20 MM A.A. GUN

20 mm Machine Gun Mechanisms, Marks 2 and 4
20 mm Gun Barrels, Marks 2, 3, 4, and 4 Mod. 1
20 mm Sights, Marks 2, 4, 4 Mod. 1, and 5
20 mm Magazines, Marks 2 and 4
20 mm Shoulder Rests, Marks 2, 4, 5, and 5 Mod. 1

O.P. 911 is changed as follows:

The purpose of this addendum is to amplify the instructions contained in O.P. 911, and to describe new tools and methods intended to increase the efficiency and safety of operation of the 20 mm A.A. gun. The following items are covered herein:

(a) BREECH FACE PIECE TOOL

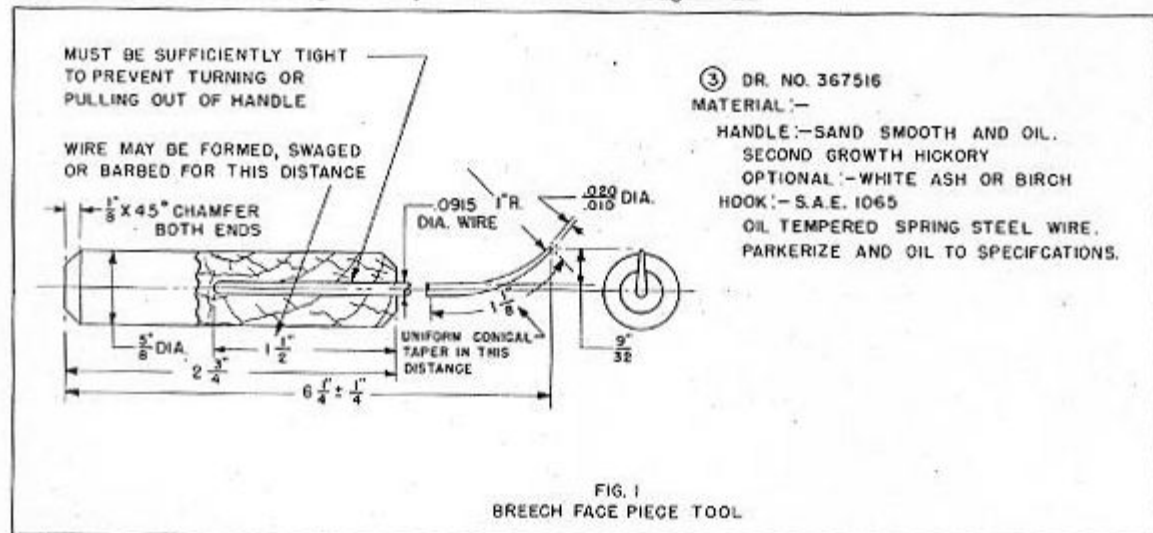
Figure 1 has been approved for production and will be furnished in the tool rolls of new guns. For guns now in service, the tool of Figure 1 may be made up by any activity that considers it desirable. A number of similar tools have been submitted by the Fleet. In one case, a common file handle was used as a grip for the tool. In another design, one end of a rod was pointed in a manner similar to that shown in Figure 1 and the other end was formed into a loop to serve as an integral handle. Any of these methods may be employed, provided that the pointed end of the tool conforms generally to that shown in Figure 1.

(b) AUXILIARY HANDLE FOR MAGAZINE

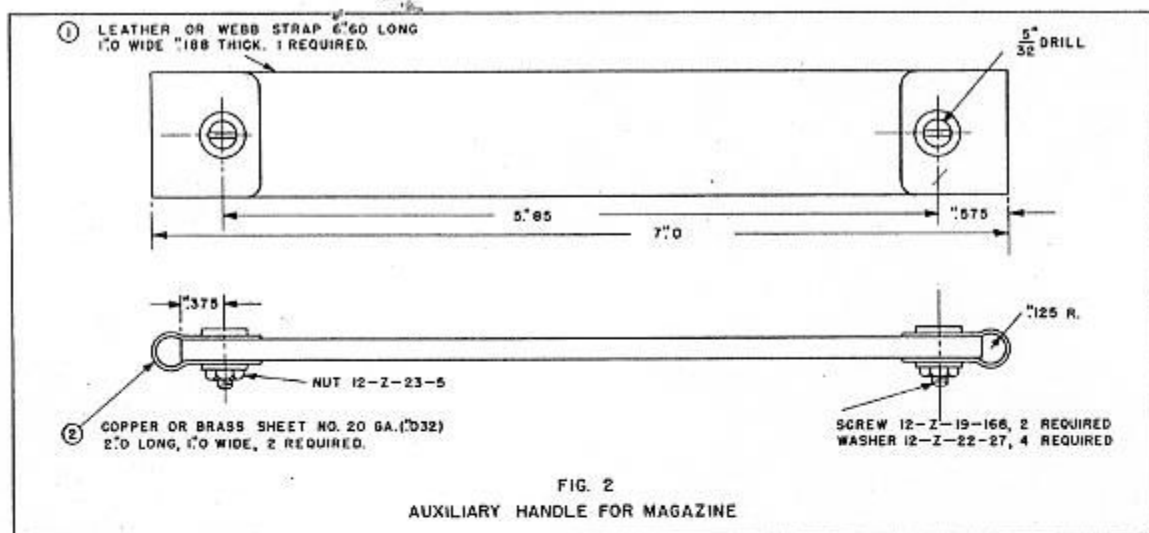
Difficulties have been encountered in removing 20 mm magazines from Type X ready service storage chests similar to NYD Norfolk Sk. No. 47237 (HuOrd. Dr. No. 332979) - 20 mm Ready Service Ammunition Chest. In this type of chest, the magazines are racked with their axes horizontal, and the handles are not readily accessible through the opening at the top of the chest.

Figure 2 shows an auxiliary handle that has been developed to aid in lifting magazines from chests of this type. The handle is fastened to the magazine by the two casing bolts which are on top when the magazine is stowed. The handle is not available for distribution to the service but may be manufactured and used by any activity that so desires.

(g) PERMANENT SET OF BARREL SPRINGS

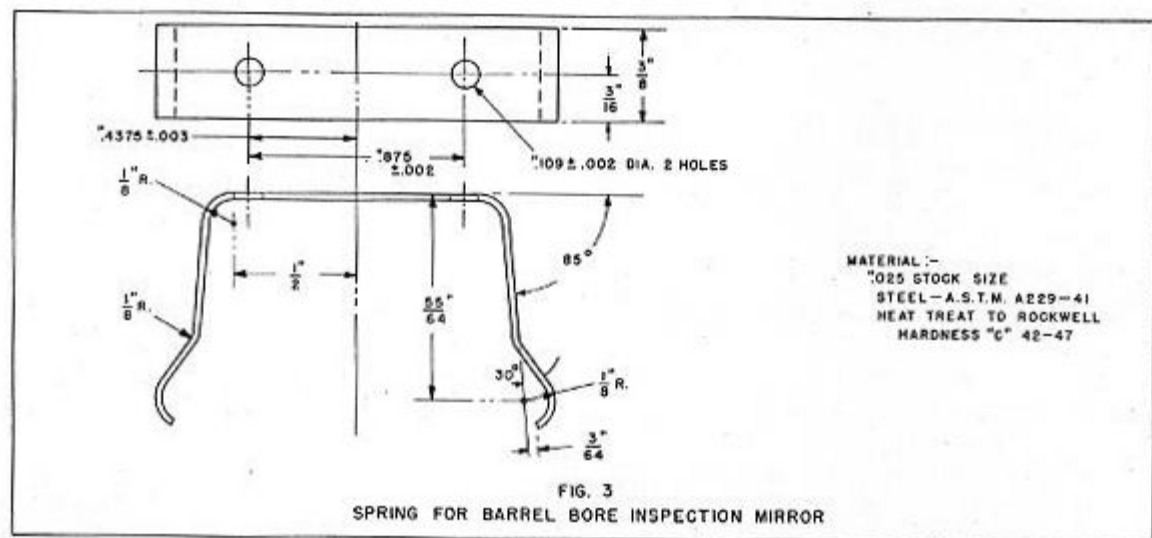
In Ordnance Pamphlet No. 813, 20 mm A.A. Gun and Mount, Mark 4 and Mark 2, it is stated that whenever possible the gun should be kept uncocked in order to relieve the spring tension and prevent the possibility of a permanent set of the barrel springs. This statement also appears in the new Ordnance Pamphlet on the 20 mm A.A. Gun, O.P. 911, which supersedes O.P. 813. However, information now at hand, based on the results of tests conducted by the Naval Gun Factory, indicates that holding the mechanism in the retracted position over long periods of time has a negligible effect upon the life of the barrel springs. It is therefore, considered a satisfactory practice, from the standpoint of barrel spring life, to keep the gun cocked during any period of readiness which the occasion demands.
